PLANNING & ZONING COMMISSION

Monday, July 22, 2024 at 6:30 PM

**PRELIMINARY PLAT**  
**LOT 1, BLOCK 1**  
**GREENWAY TRAILS**  
 ALSO BEING A REPLAT OF LOT 1, PRIDDY ADDITION, AN ADDITION TO THE CITY OF CORINTH ACCORDING TO THE PLAT RECORDED IN CAB. N, SL. 382, PLAT RECORDS, DENTON COUNTY, TEXAS  
 M.E.P. & P. R.R. CO. SURVEY, ABSTRACT No. 911  
 CITY OF CORINTH, DENTON COUNTY, TEXAS  
 GROSS AREA: 14.1681 ACRES  
 ZONED: PLANNED DEVELOPMENT DISTRICT #63 (GREENWAY TRAILS)

<b>Meeting Date:</b>	7/22/2024	<b>Title:</b>	Enclave at Canyon Ranch Planned Development (PD) Rezoning Request (Case No. ZAPD24-0003)
<b>Strategic Goals:</b>	<input type="checkbox"/> Resident Engagement <input type="checkbox"/> Proactive Government <input type="checkbox"/> Organizational Development <input type="checkbox"/> Health & Safety <input type="checkbox"/> Regional Cooperation <input checked="" type="checkbox"/> Attracting Quality Development

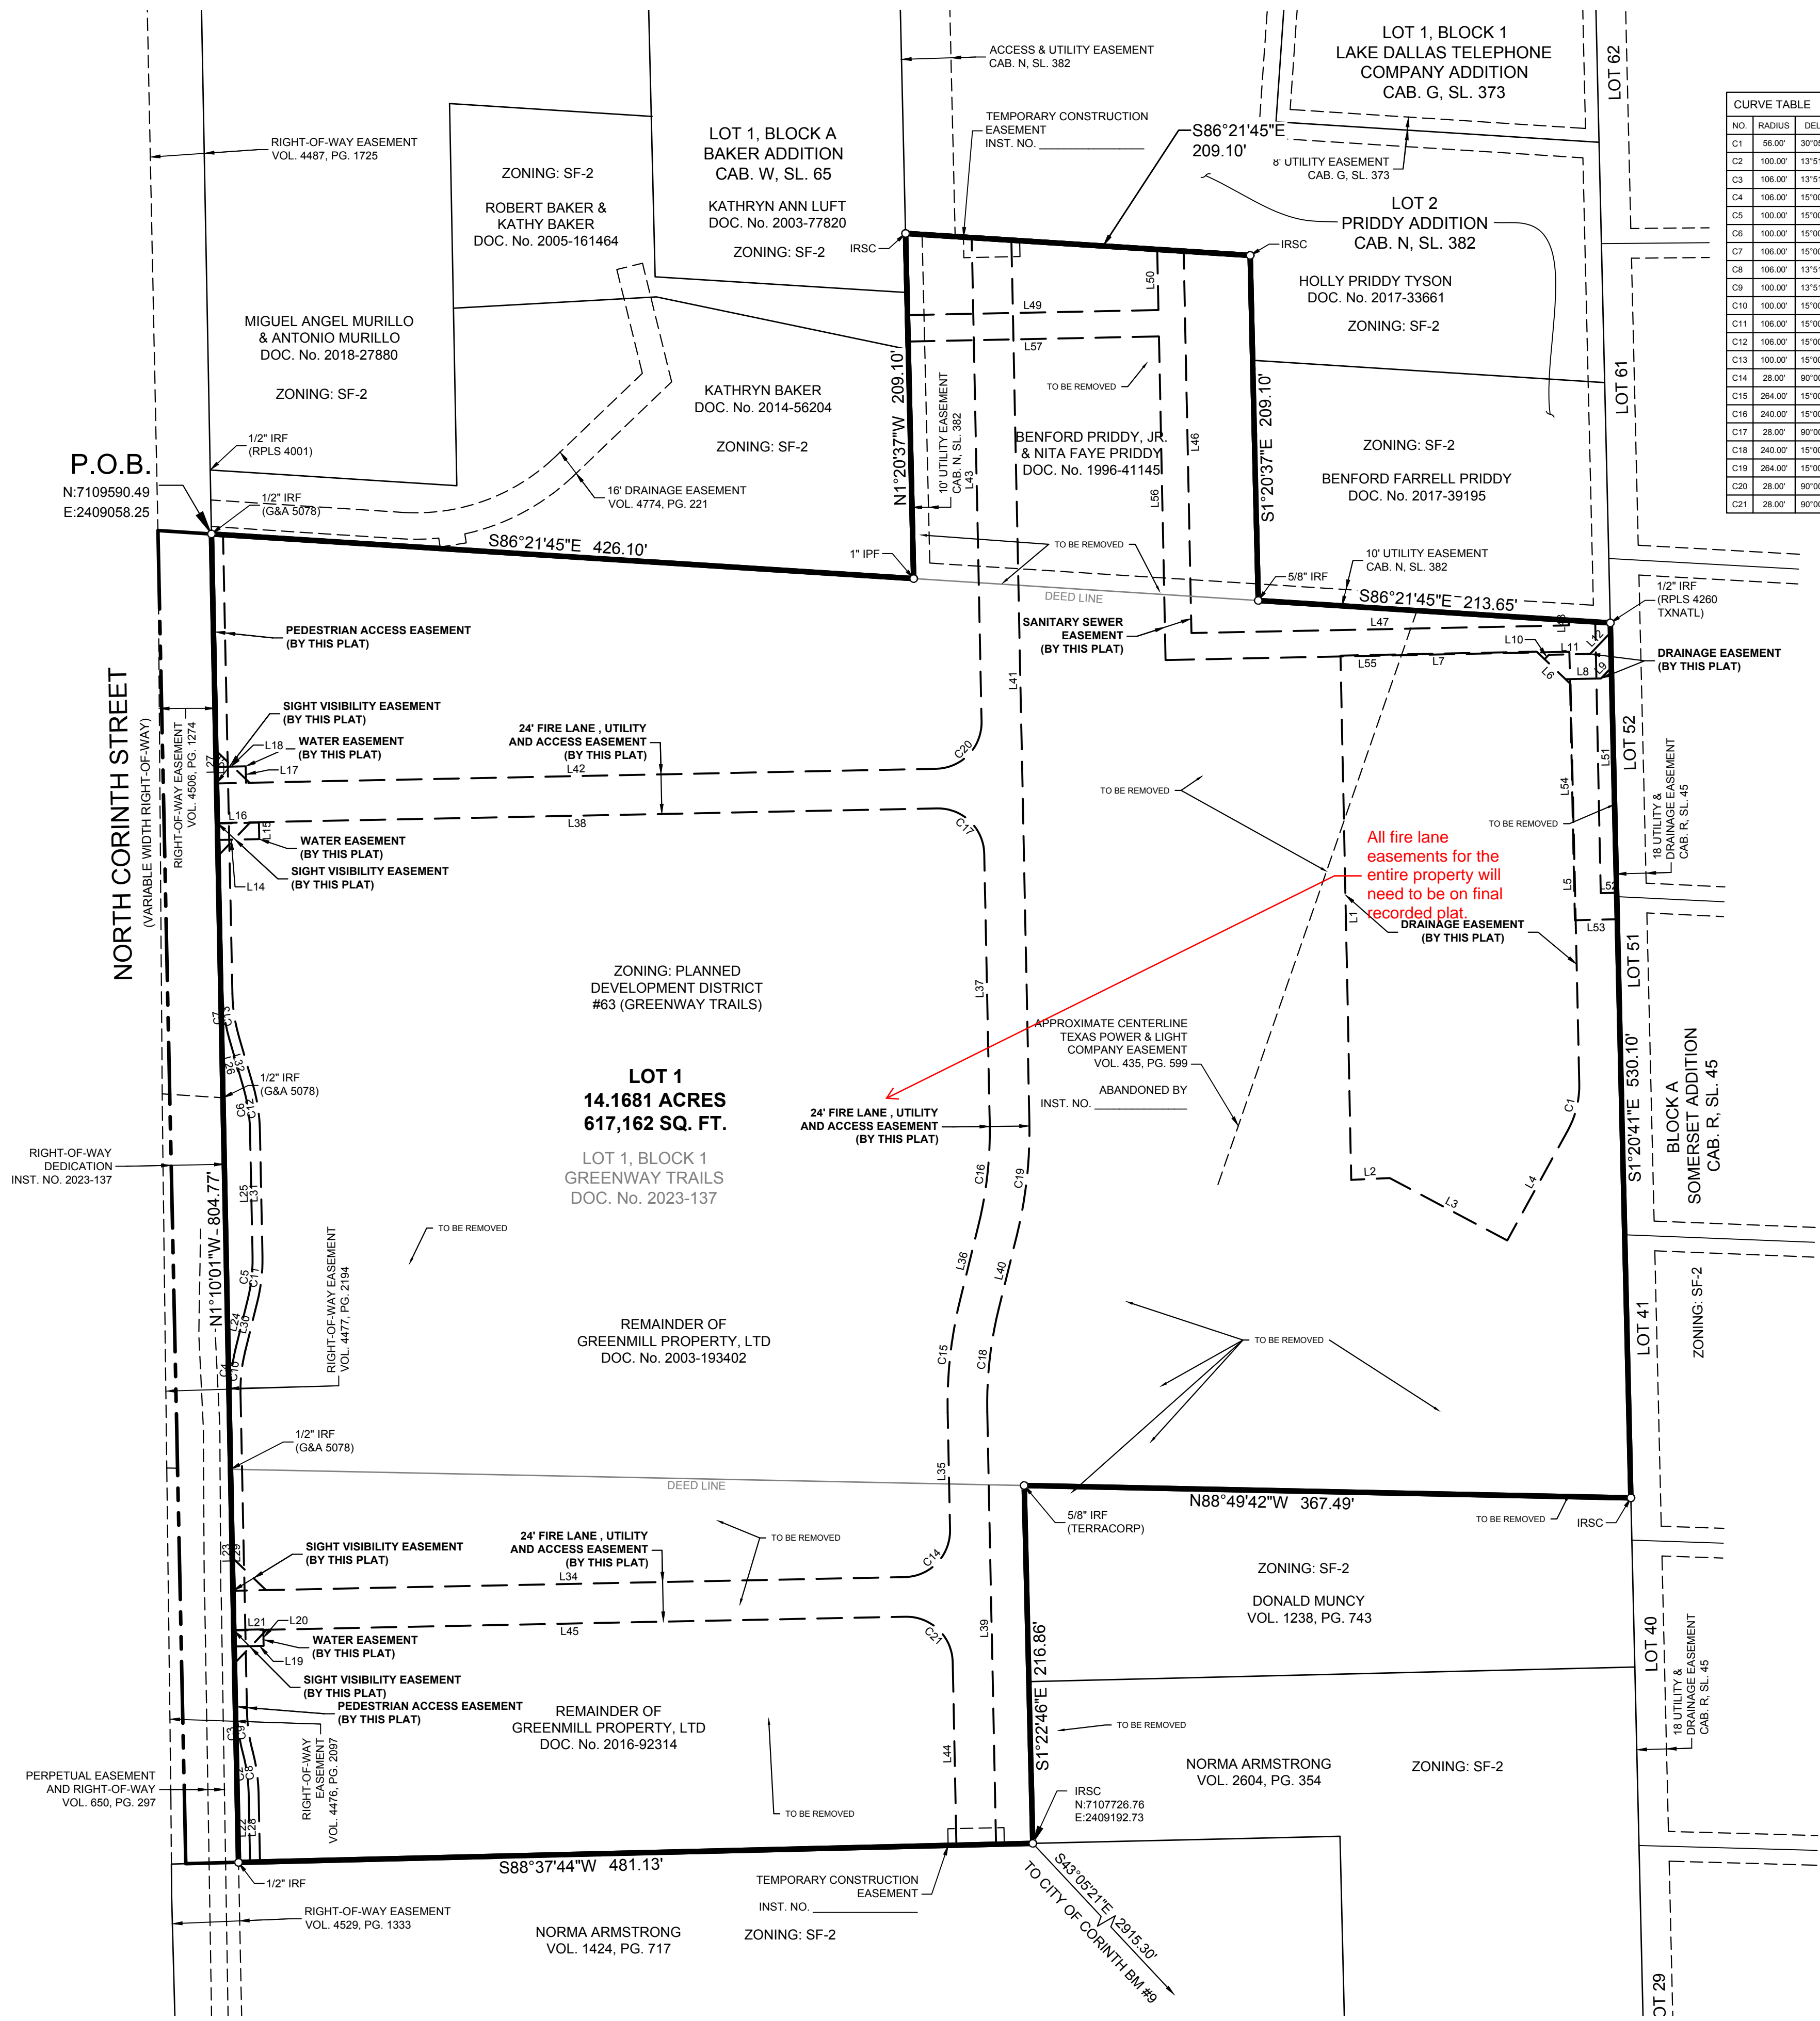
Add setback lines  
 Show existing structures with notation "to be demolished or removed"  
 Label continuous and adjacent properties around proposed development (lots, blocks, tracts, abstracts, names, owners, platted or un-platted, existing zoning, and proposed land use designation).

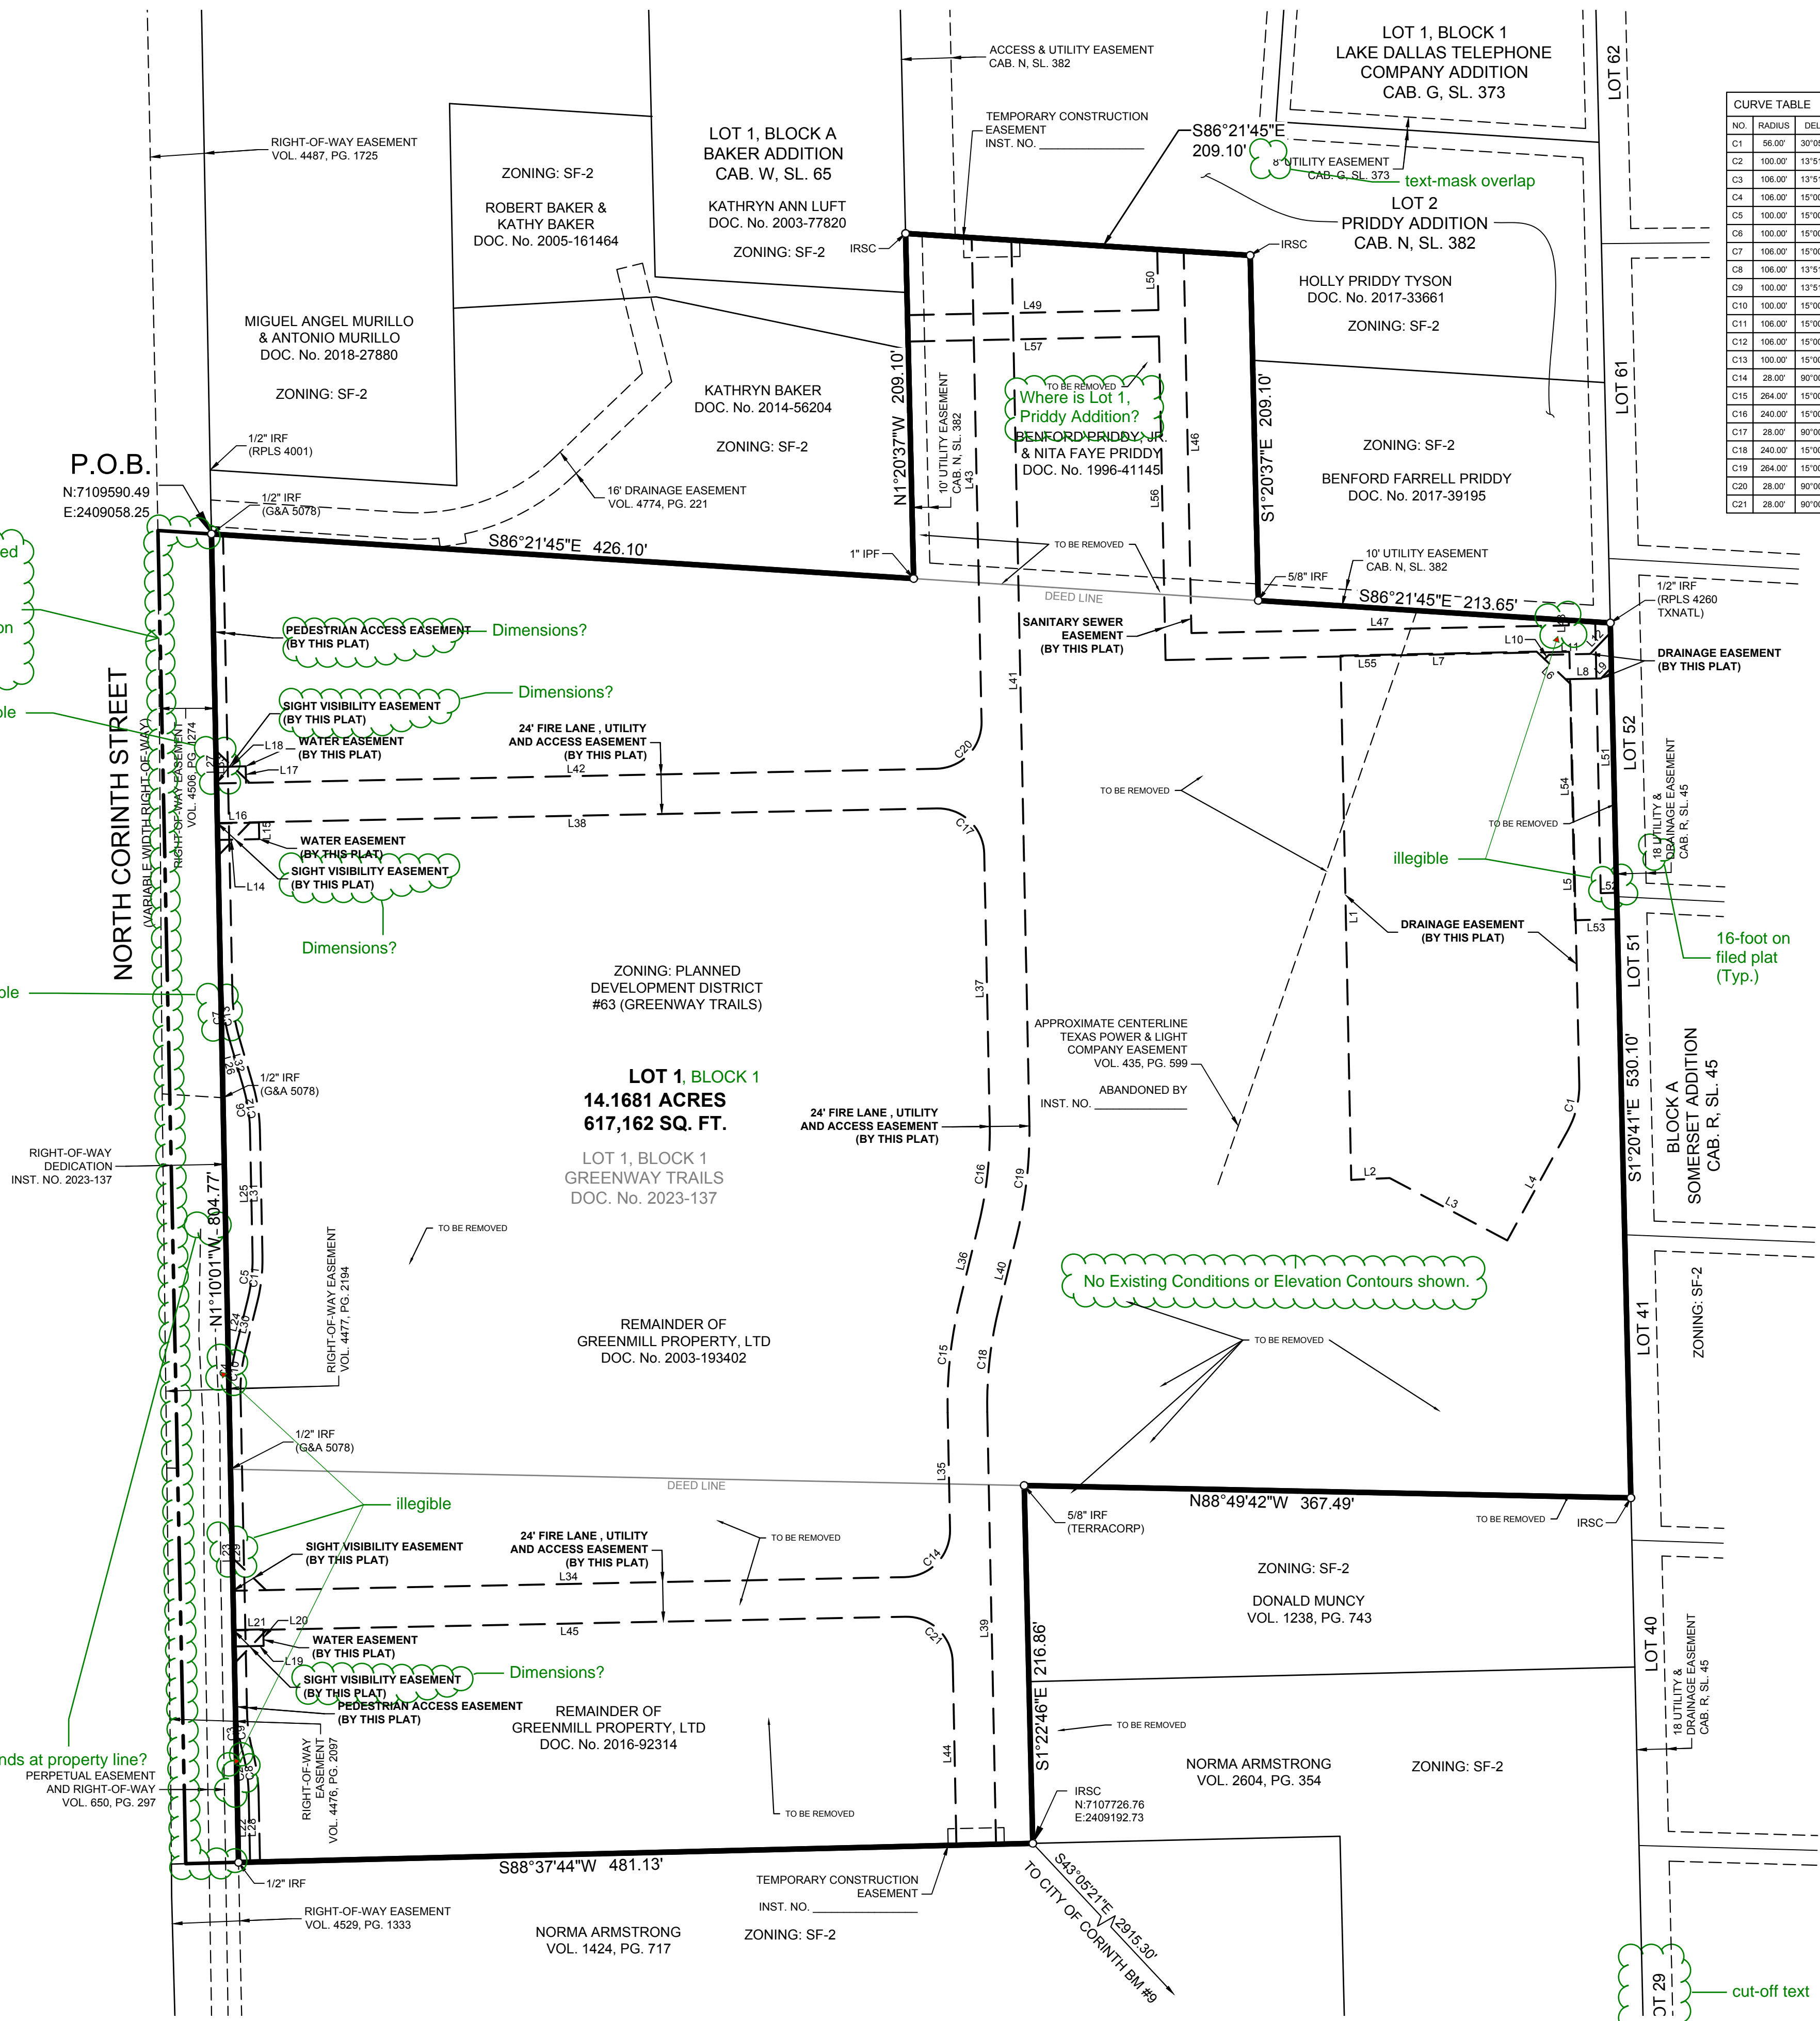
Conveyance plat included R.O.W. Dedication Heavy line required? Is this R.O.W. Dedication in conformance with Comp. Plan.
